SERVICE BULLETIN

N° 139-699

ATA 33 – TAIL ROTOR LIGHTS IMPROVEMENT

This Service Bulletin is issued to provide the necessary instruction to perform the Tail Rotor Lights retromod P/N 3G3340P02011.

Figure 5

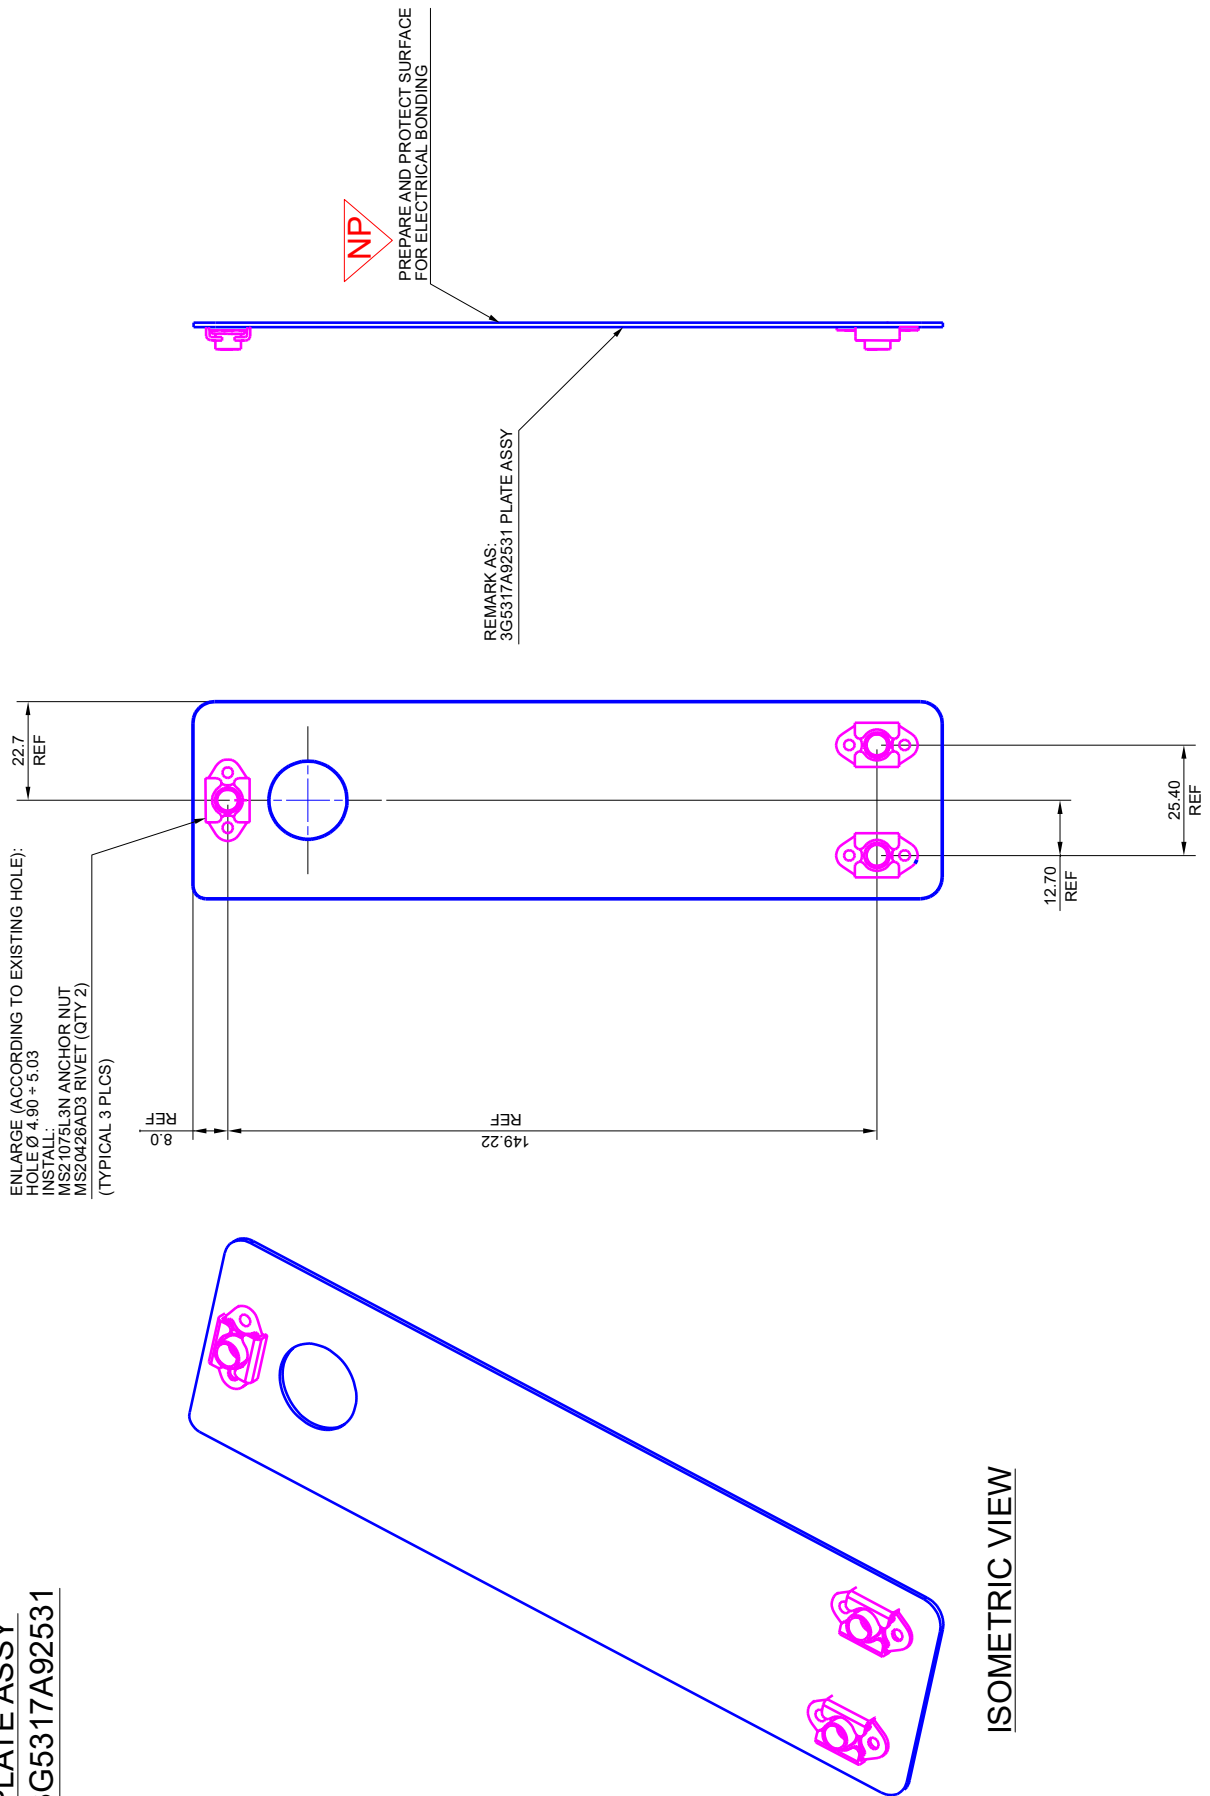
- 2.1.5 With reference to Figure 5, assemble the two plate assy P/N 3G5317A92531 as follows:
 - 2.1.5.1 With reference to Figure 5, enlarge n°3 holes \varnothing 4.90 – 5.03 on each plate 3G5317A92551M01.

- 2.1.5.2 With reference to Figure 5, install n°3 anchor nuts P/N MS21075L3N on each plate 3G5317A92551M01 by means of n°6 rivets P/N MS20426AD3-4.
 - 2.1.5.3 With reference to Figure 5, remark each plate assy as 3G5317A92531.
